ECool BPM Changes

Cooling Section BPM Changes

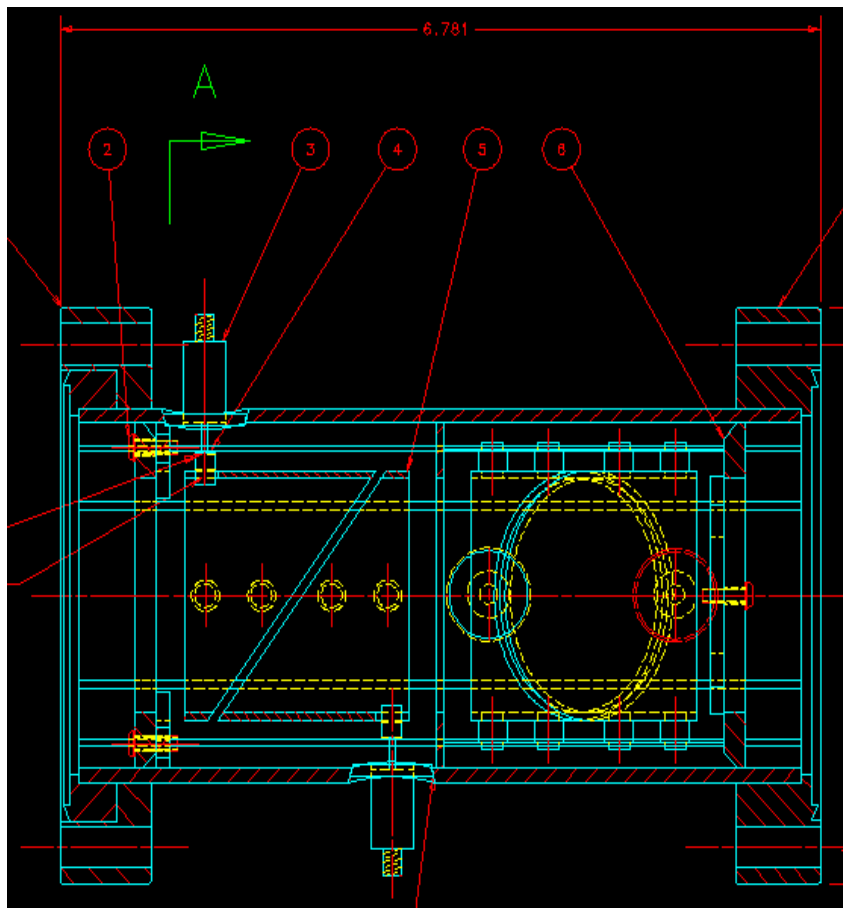
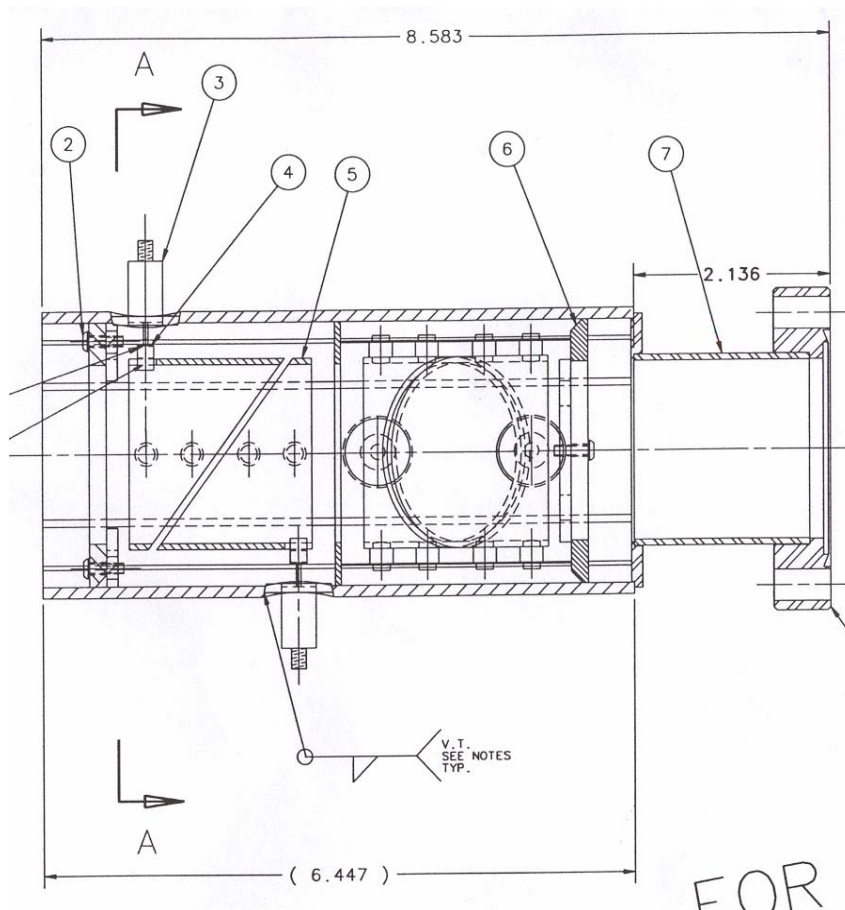
- Tubes: tighter tolerances
- Feedthru plug
 - Added weld relief
 - Revised dimensions on plug and hole
- Guide plate: rounded edges
- Guide plate/pickups: deburring note - no scratches
- Pickups: wire cut only
- Feducial: for rotation
 - scribe line during mfg & reference to hole in flange
 - AND EE Support use locating fixture

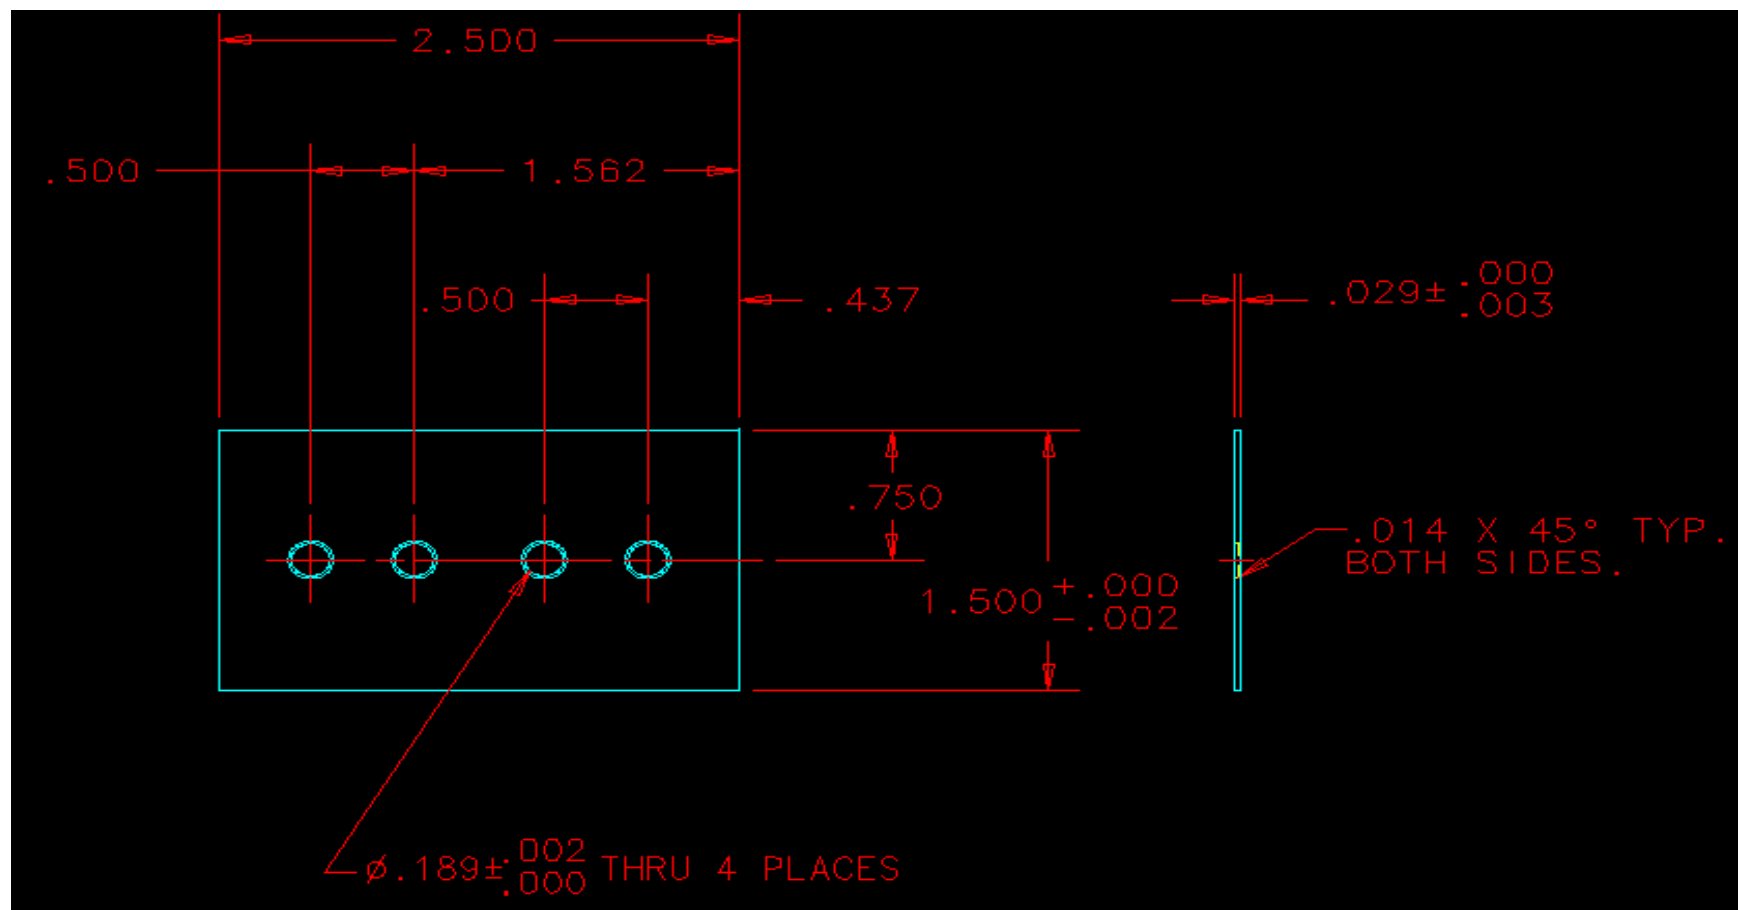
- Accommodations for magnetic measurement cart
 - Centering rings: larger ID
 - Extension of beamtube closer to end centering ring
